From: Dee Miller [deemiller@tampabay.rr.com]
Sent: Tuesday, June 14, 2011 1:57 PM
To: Kothur, Bheem; Dregne, James
Cc: Noble, Ron
Subject: Permit: 294693-HO-001:294693-SO-002
Attachments: AQ 001 REV 3.pdf; AQ 002 REV 3.pdf; AQ 003 REV 1.pdf

Florida Recycling Solutions, LLC.		LAKELAND, FLORIDA	
MATERIAL		TREATMENT	
TITLE FINISHED OIL FLOW DIAGRAM			
OWN BY SPC	SCALE 1:1	DWG NO.	REV.
CHKD	DATE	002	-3

AQUA CLEAN ENVIRONMENTAL CO. LAKELAND, FLORIDA		TREATMENT	
TITLE		FRS PIPING AND MECHANICAL ARRANGEMENT	
DRAWN BY		SCALE N.T.S.	
DATE		DWG NO.	
CHECKED BY		DATE	
APPROVED BY		REV.	
1		001	
2		-3

Re: Revision to Piping Plan for Florida Recycling Solutions, LLC Used Oil and
Material Processing facility Permit
EPA ID No.: FLR 000 034 033
FDEP Permit No.: 294693-HO-001; and 294693-SO-002
Lakeland, Polk County, Florida

11C

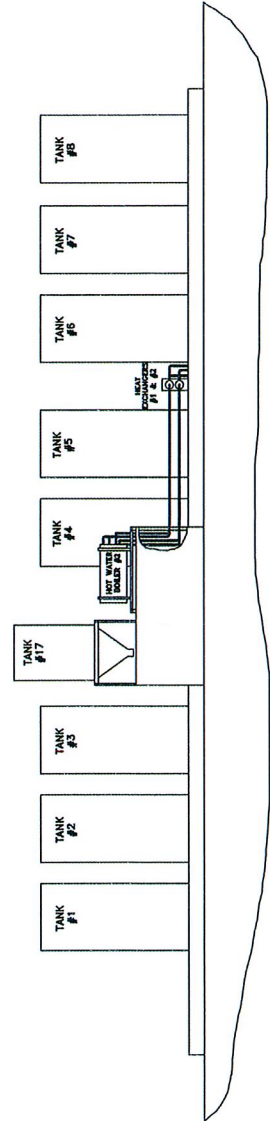
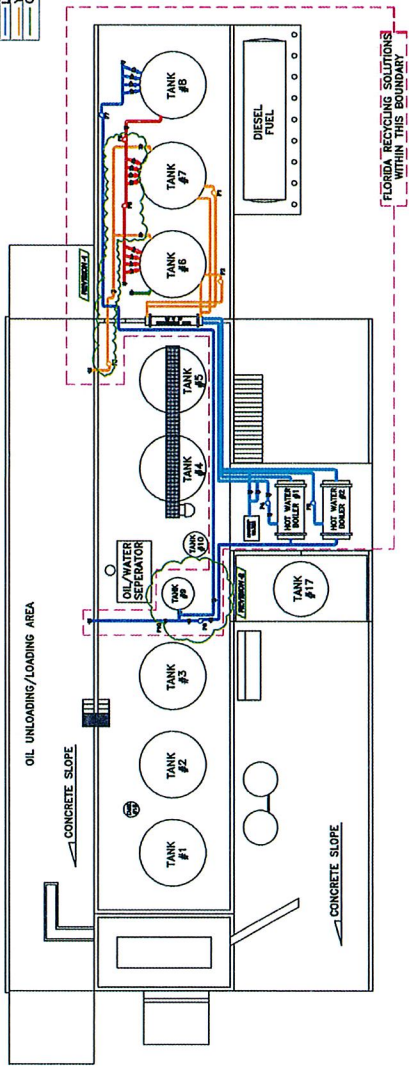
Please clarify where does Oil/Water Mix from Tank 8 go? There is not an Oil Water Mix line here. Please review these two drawings and revise as appropriate.

As you know, based on your discussions with DEP/SW District (Jim Dregne) on June 8, 2011 about our comments regarding the Tank 8 and its piping connection. DEP is satisfied With your explanation and the use of Tank 8 piping related issues.

Accordingly, please revise the appropriate as-built drawings as per the discussion with Jim Dregne and re-submit the revised drawings for our approval and record. Upon receiving and approving the as built drawings by the department, facility may start using those tanks to store the used oil and processing it (PART II.7 and 8 of the permit issued dated May 12, 2011).

We do not believe any revisions to either of the drawings are necessary to respond to the Department's inquiry. Specifically, there is no oil/water mixture generated from Tank 8. That tank is the finished oil storage tank as set forth in the Permit Application and backup documentation for this facility. If there is ever a need to remove water from the bottom of Tank 8, FRS maintains a fitting at the bottom of this tank that can be connected to a flexible hose.

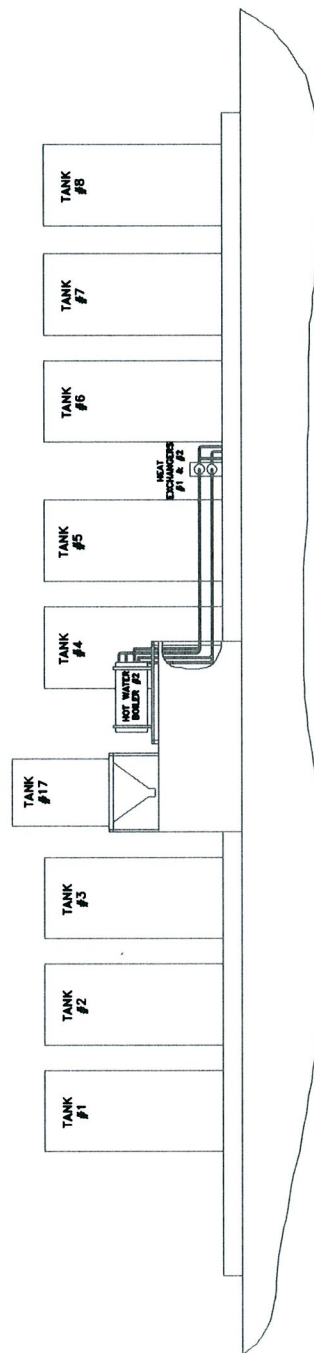
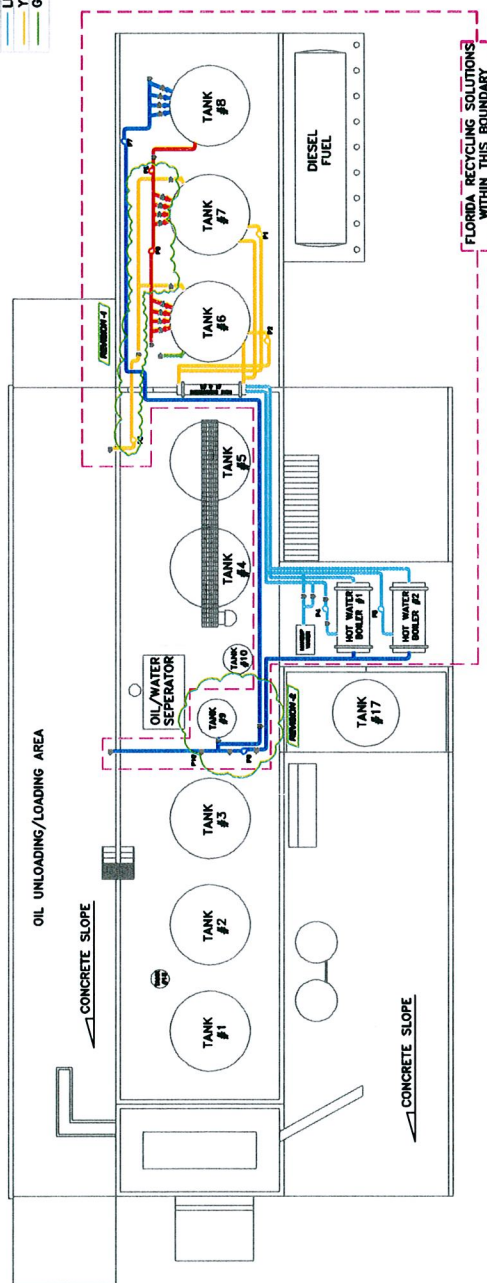
1. Drawing No. 002, Finished Oil Flow Diagram (IIa): No comments
2. Drawing No. 003, Oil Separation Flow Diagram (IIb) and Drawing Number No 001, FRS Piping And Mechanical Arrangement (IIC):

Please clarify where does Oil/Water Mix from Tank 8 go? There is not an Oil Water Mix line here. Please review these two drawings and revise as appropriate.

As you know, based on your discussions with DEP/SW District (Jim Dregne) on June 8, 2011 about our comments regarding the Tank 8 and its piping connection. DEP is satisfied With your explanation and the use of Tank 8 piping related issues.

Please revise and reflect the changes in as appropriate as-built drawings^{as per the discussion with Jim Dregne} and re-submit the revised drawings for our approval and record. Upon receiving and approving the as built drawings by the department, facility may start using those tanks to store the used oil and processing it (PART II.7 and 8 of the permit issued dated May 12, 2011).

We do not believe any revisions to either of the drawings are necessary to respond to the Department's inquiry. Specifically, there is no oil/water mixture generated from Tank 8. That tank is the finished oil storage tank as set forth in the Permit Application and backup documentation for this facility. If there is ever a need to remove water from the bottom of Tank 8, FRS maintains a fitting at the bottom of this tank that can be connected to a flexible hose.
